# **Troubleshooting Guide**

# **imageRUNNER ADVANCE**

# **8500 III/6500 III Series**

September, 2019  
OIP Field Quality Assurance Div.

Measures against a stain on the leading edge of the image due to the torsion spring breakage

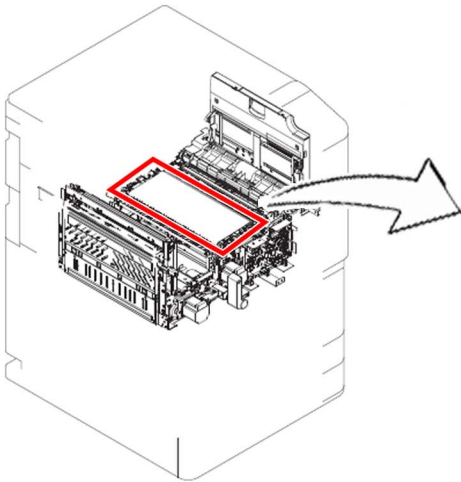
In the machines prior to the countermeasure cut-in serial number in factory described below, a stain seemingly caused by rubbing may occur on the leading edge of the image.

On the leading edge of the torsion spring on the rear side [a] and the front side [b] of the ETB unit [1], pressure is applied to the pre-transfer guide of the pre-transfer corona assembly to position the pre-transfer guide. After some endurance time, the torsion spring will not be able to slide well and a load will be applied, causing breakage.

This will lower the position of the pre-transfer guide and cause it to touch paper, resulting in the above-mentioned symptom. [2] shows the torsion spring broken on the front side [b].

If the above-mentioned symptom occurs, prepare the new-type torsion springs and replace them by referring to Service Manual "Removing the ETB Unit".

It is recommended replacing the torsion springs on both the front side and rear side at the same time even if the torsion spring only on one side is broken.

Old type	New type
Torsion spring(front side)

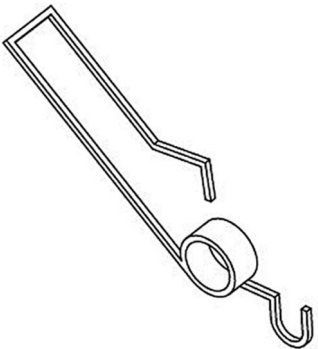
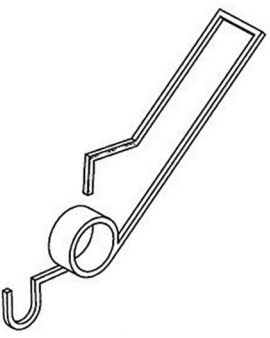
Old type	New type
Torsion spring(rear side)

**Abnormal noise around DC motor, and shifting operation failure due to spring pin breakage of output gear.**

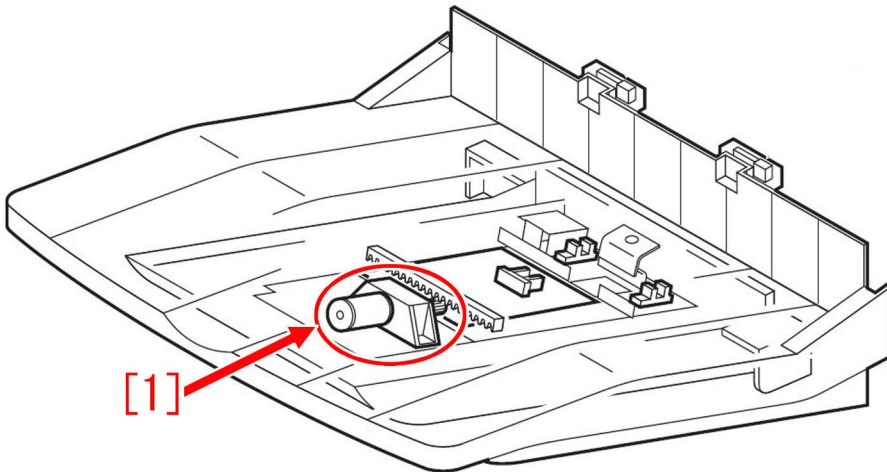
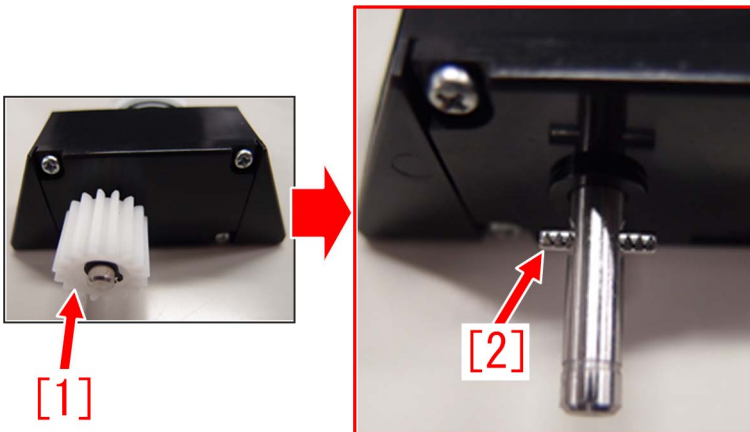
In the machine earlier than the following countermeasure cut-in serial numbers in factory, when using Shift Tray-F1, abnormal noise around the DC motor [1] or an operational failure such as not shifting may occur.

When DC motor have been used for a long time, a spring pin [2] of output gear [1] may break. For this reason, normal operation of the output gear [1] is prevented, and this leads to the afore-mentioned symptom.

When the above symptom occurs, prepare a new type of DC motor (FK3-3277-010) and follow the steps below to replace the part.

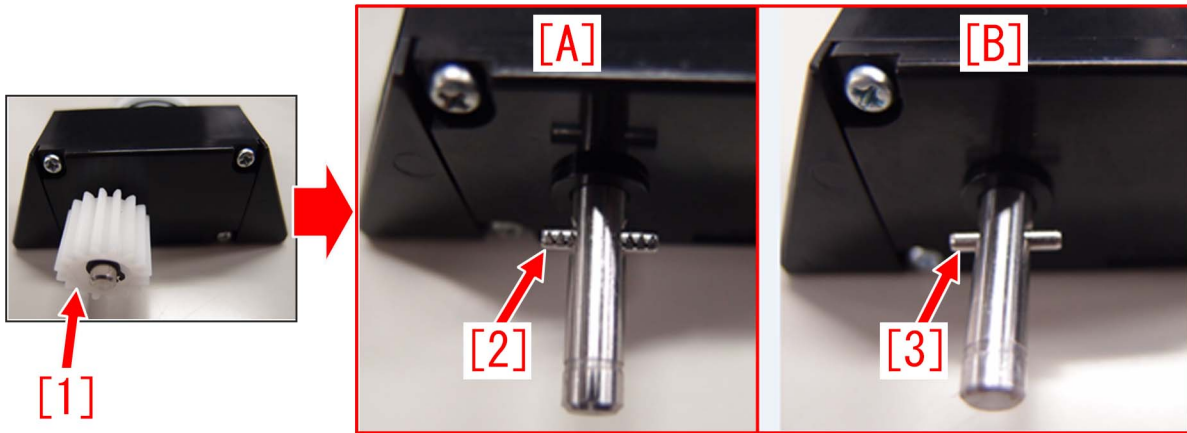
[Reference] Spring pin [2] used in the output gear [1] of the new type DC Motor [B] is changed to a dowel pin [3], for strengthening purpose. [A] is an old type.

- 1) Refer to Service Manual to remove the DC motor.  
Service manual > 4. Disassembly/Assembly > Drive System > "Removing the Tray Drive Unit"

- 2) Rotate the output gear of the DC motor by hand, and if the gear does rotate, proceed to step3). If the gear does not rotate, look for other reasons.

3) If the output gear does rotate by hand, the spring pin is broken. Replace with a new type of DC Motor (FK3-3277-010), and assemble the parts by following the reverse order as removed.

# Measure against when either right pickup deck or left pickup deck could not be pulled out

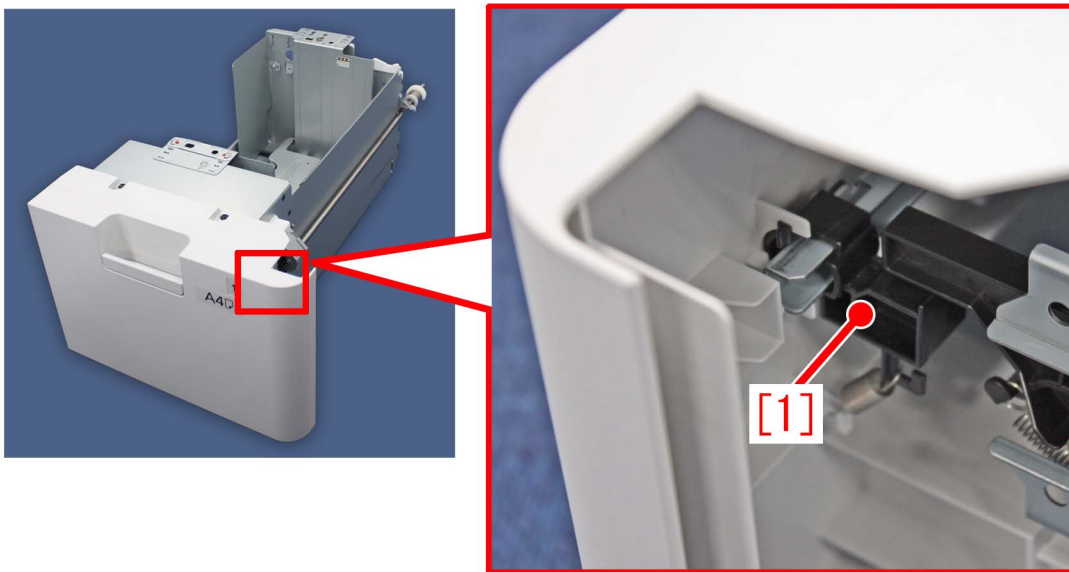
Due to impact to either right pickup deck or left pickup deck when they were opened/closed, the deck lever [1], which is located near the handle, may break from its stress. With this damage, open/close lock could no more function to release, resulting in the above-mentioned symptom.

Photos below are showing the deck lever [1] on a right pickup deck of the iR-ADV 6500 Series machine.

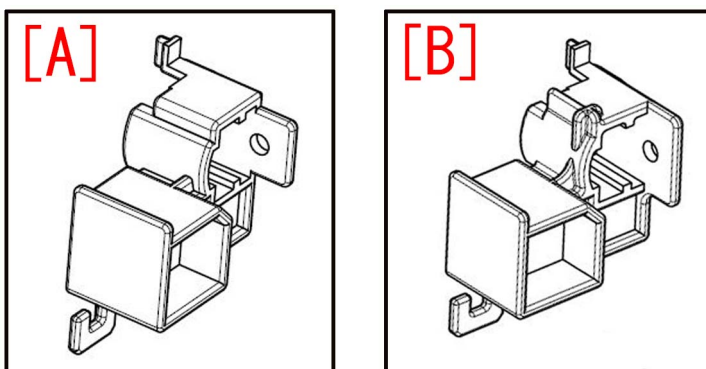
When the above-mentioned symptom occurs, prepare the new type of deck lever (FE4-1289-010) and replace with it. Shown below, fig [A] is the old type and [B] is the new type of deck lever. The new type has its shape changed, to strengthen the part where stress is applied when the decks were opened/closed.

## 110F jam code due to meshing failure on timing belt of operation feed motor (M26) (Staple/Saddle/Booklet/Finisher)

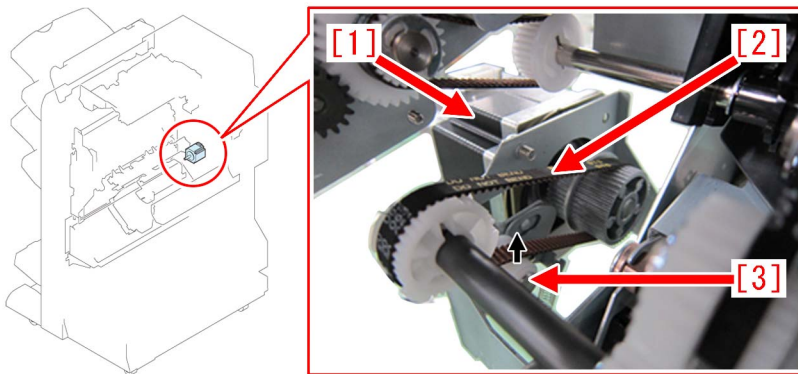
In the machine earlier than the following countermeasure cut-in serial numbers in factory, when printing using the finisher, 110F jam may occur.

The timing belt [2] in the operation feed motor (M26) [1] is designed to keep its tension and prevent from being loose by having the tensioner [3] pressed in the direction of the arrow. This tensioning method is "unfixed type". However, the pressing power of the tensioner [3] in the unfixed type is insufficient in some cases and when the operation feed motor (M26) [1] drives rapidly a meshing failure occurs on the timing belt because of power, resulting in the above symptom.

When the above symptom occurs, prepare and replace the paper delivery drive set (L) (4Y8-3156-000).

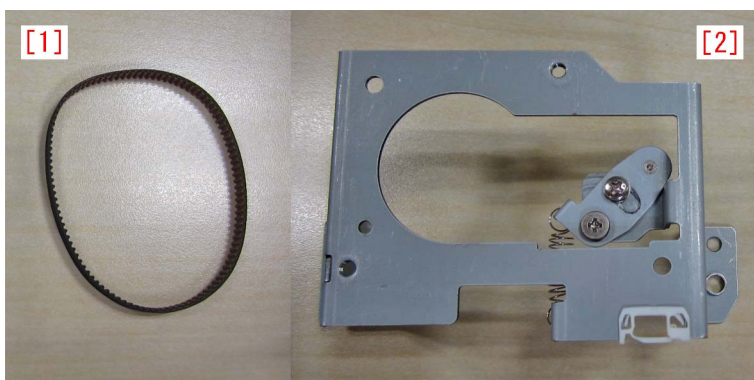
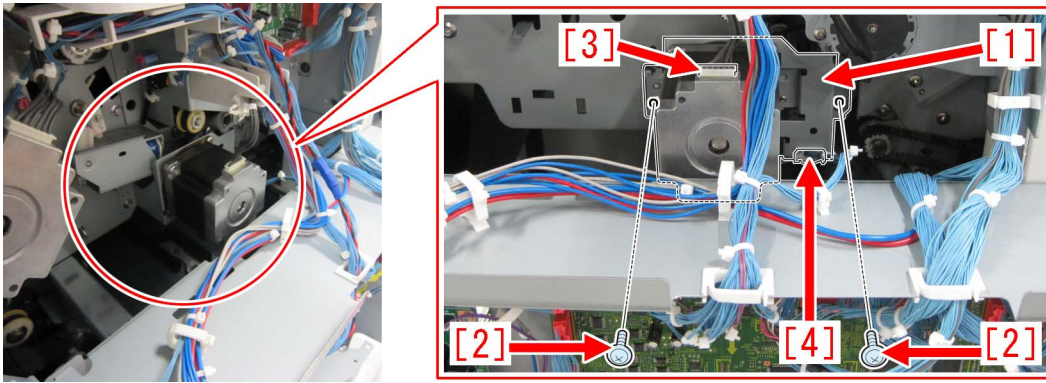
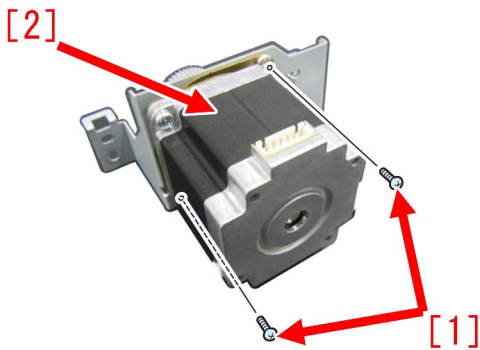
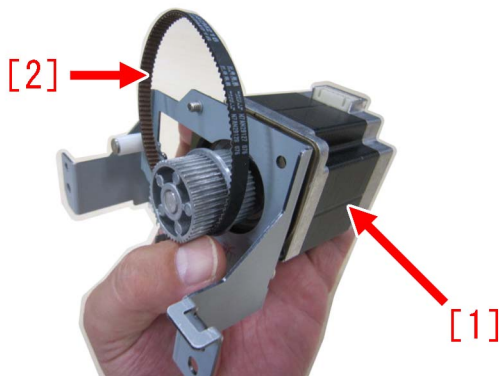
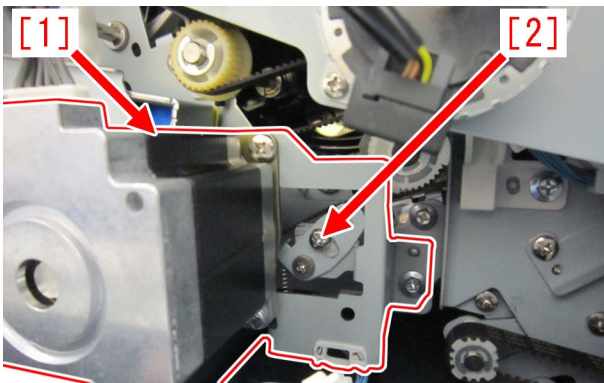
- Timing belt [1]
- Paper delivery drive assembly (L) [2]

- 1) Refer to "Removing the Rear Cover" of Service Manual and remove the rear cover.
- 2) Remove the 2 screws [2], the connector [3] and the edge saddle [4], and then remove the paper delivery drive assembly (L) [1] including the motor.

3) Remove the 2 screws [1] and then remove the motor [2]. Then, attach the motor to the paper delivery drive assembly (L) which is included in the set. To attach the motor, use the 2 screws that were previously removed [1].

4) After attaching the timing belt [2] that is included in the set to the paper delivery drive assembly (L) [1] with the motor attached, attach the whole thing to the machine using the 2 screws removed in the step 2).

5) Loosen the screw [2] on the tensioner plate of the paper delivery drive assembly (L) [1]. (By loosening the screw, tension is applied to the timing belt.)

6) Tighten the screw which was loosened in the step 5) and attach the rear cover.  
[ Service parts]

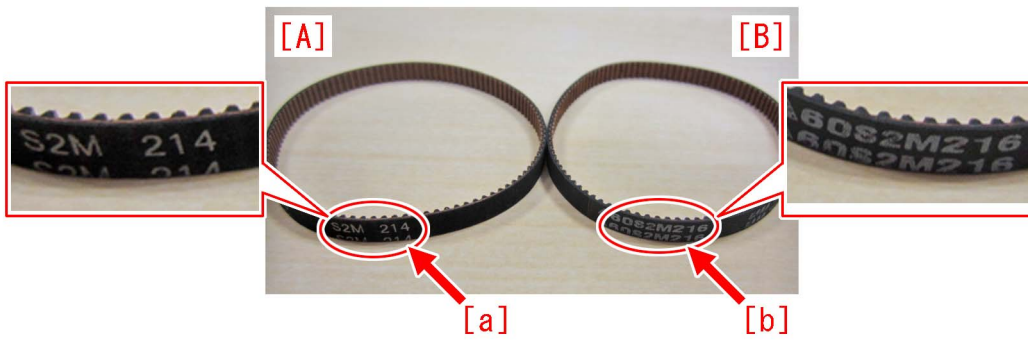
[Note] When replacing to the paper delivery drive assembly (L), be sure to also replace the timing belt [B] at the same time that is included in the set. 110F jam occurs when using the old type timing belt [A] as the number of teeth of the new type is different from the old type originally attached to the engine.

In the photo below, [A] is the old type and [B] is the new type.

The old type [A] has "S2M 214" [a] printed on it. The new type [B] has "60S2M216" [b] printed on it.

## Points to note when attaching tension spring of the Buffer/Saddle Inlet Flapper(Staple Finisher-V1/V2/Y1/AA1 Booklet Finisher-V1/V2/Y1/AA1)

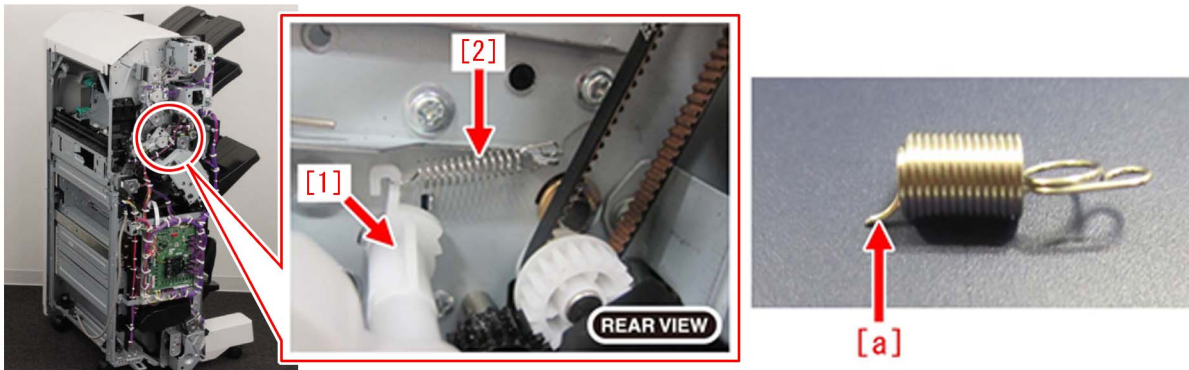
When the tension spring (FE3-8986-000) [2], which has the role to retain the home position of the Buffer/Saddle Inlet Flapper[1] is attached in a twisted condition, it may break [a] during operation. If this tension spring breaks, it may lead to 1002 jam.

Below, photo [A] is showing the normal condition. The spring is attached correctly. Photo [B] is showing the incorrect status.

When attaching the tension spring of the Buffer/Saddle Inlet Flapper, do not twist its hook.
